Huntlee – Stage 1 MP10_0137 Modification 20 – Response to Request for Further Information

Ethos Urban has prepared this letter for Huntlee Pty Ltd regarding the section 4.55(2) Modification Application (MOD 20) to Project Approval MP10_0137, relating to the Huntlee New Town, Branxton. The purpose of this letter is to provide a Response to a Request for Further Information (RFI) addressing the issues raised by the Department of Planning and Environment (DPE) in the letter dated 3 August 2022, specifically relating to Transport for NSW comments received.

Figure 1 Existing TC4 proposed layout (left) and amended TC4 layout (right)

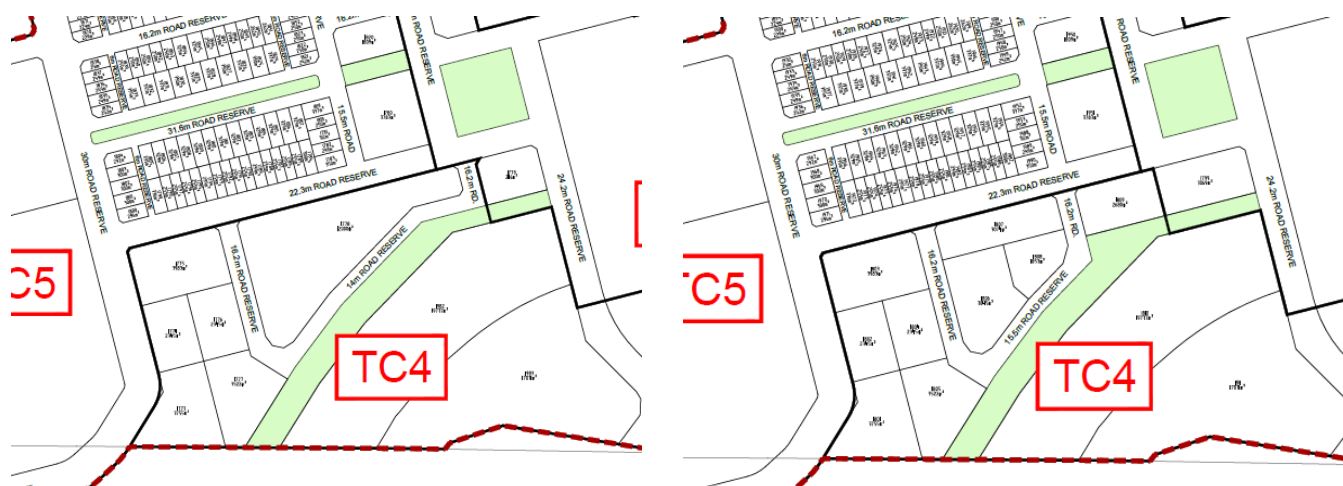
Due to discussions with Cessnock Council in relation to open space and landscape embellishments, the community hub area as proposed in the original submission of Modification 20 is proposed to be removed and located outside of the Stage 1 Project boundary, which is understood to be Council's preference (noting Council's submission on Modification 20 indicated the shape and configuration of some open space may result it in being unfit for purpose with further consultation needed). Huntlee Pty Ltd have also confirmed that the amended Community Hub aligns with the amended Council VPA plans, currently under discussion with the relevant Council officers.

The previously proposed Community Hub Lot 1178 (being an infrastructure, community and education lot) is now proposed to be subdivided into four commercial/mixed use lots. These changes are provided below.

There is a slight adjustment to the staging boundary between TC4 and TC3 to reflect.
